**ROTAX****S E R V I C E I N F O R M A T I O N**

7 UL 97-D/E

August 1997

Kalibrierung der Gemischanreicherndüse bei Rotax 914 UL (Serie)**Calibration of the mixture enrichment jet of ROTAX 914 UL (series)****Vorgeschrieben / mandatory****1) Wiederkehrende Symbole:**

See fig. 1 and 2

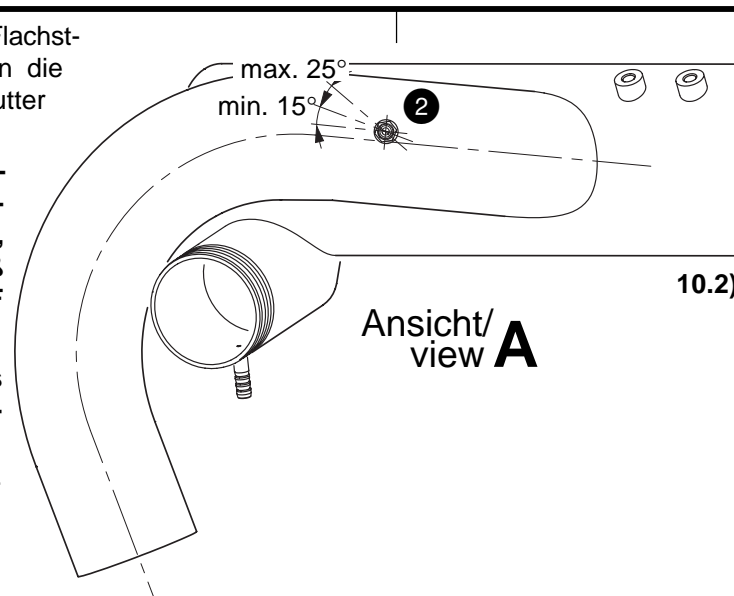
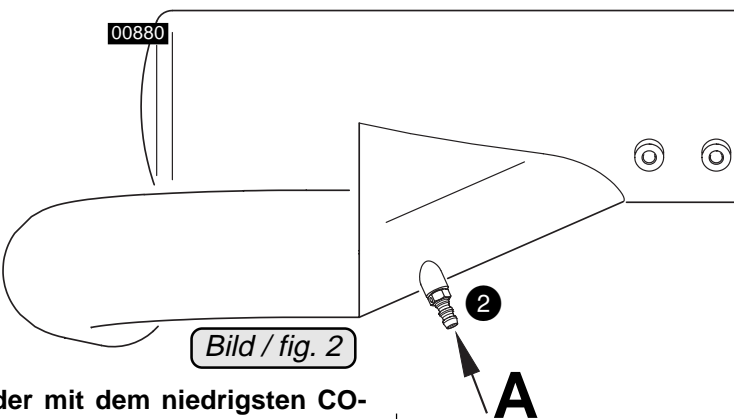
On the engines affected the pressure control bore of the mixture enrichment jet might be badly positioned, resulting in a too lean mixture at take-off performance.

The pressure control bore ① in the mixture enrichment jet ② has to be positioned min. 15° to max. 25° deviating to the theoretical flow direction.

◆ **NOTE:** This becomes necessary as the turbo charger causes a twist of the air flow which would result in an unfavourable angle of attack on the pressure control bore, if the mixture enrichment jet is installed straight.

The position of the pressure control bore is indicated clearly by the counter sinking ③ on the hexagon. See fig. 1 and 2.

With the longitudinal axis of the intake tube as reference, mark the tube at an angle of 15° to 25° in clockwise direction.

Afterwards slacken the locknut and readjust enrichment jet by aligning counter sinking ③ on hexagon with mark on intake tube. Tighten lock nut and secure with paint.
